MOTORCYCLE SERVICE NEWS

NUMBER 346

TX750 CRANKSHAFT AND ROD JOURNALS, Size Code Location Change

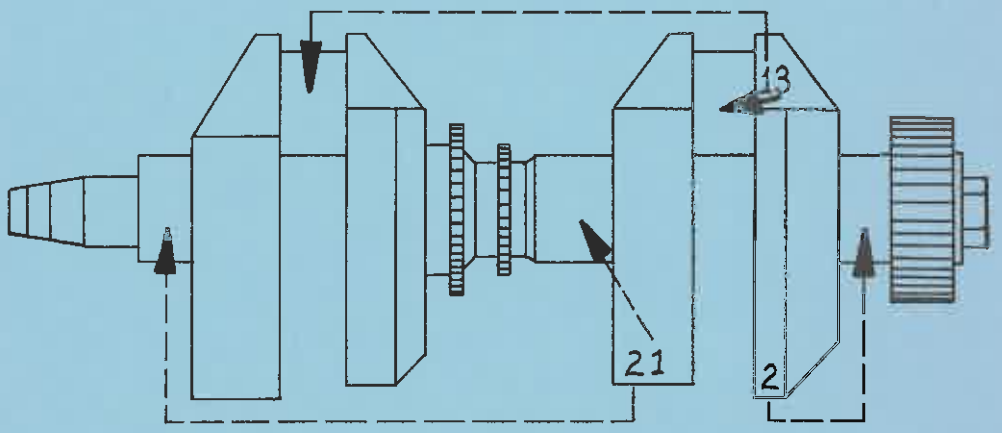
Main Bearing and Rod Bearing journal sizes are identified by code numbers stamped on the webs. The locations of these code numbers have been changed. The illustration below shows the new number location and the journal applicable to that location.

Currently, production units are still using the old numbering system. Crankshafts from parts stock, however, employ the new system.
